# Access Compliance Report

## Public Rights-of-Way

### (Curb Ramps)

| Intersection ID: 23277                  | Main Street: S_TRYON_ST | Cross Street: JOHN_PRICE_RD             | Location: NE           |

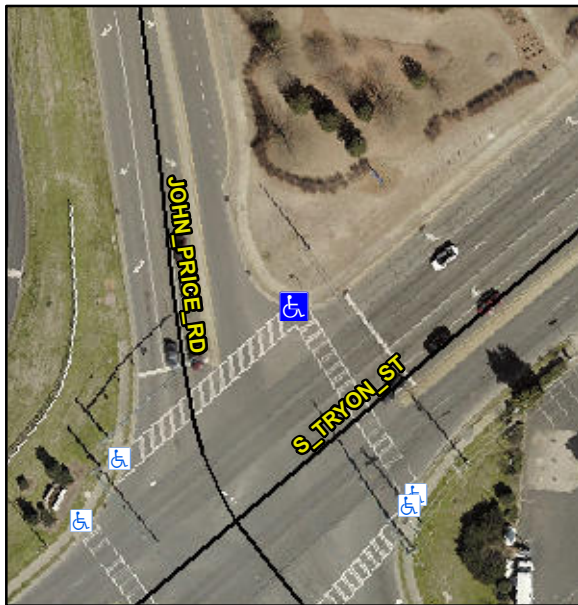
**Not Found, R304.2.2, R304.5.3**

| Compliance | Description           | Data  | Compliance | Description                 | Data  |
|------------|-----------------------|-------|------------|-----------------------------|-------|
| N/A        | Ramp Length (in)      | 60.0  | No         | Ramp Slope (%)              | 9.1   |
| Yes        | Ramp Width (in)       | 50.0  | No         | Ramp XSlope (%)             | 7.1   |

**Remove & Replace Curb Ramp With Two New Directional Ramps or Equivalent.**
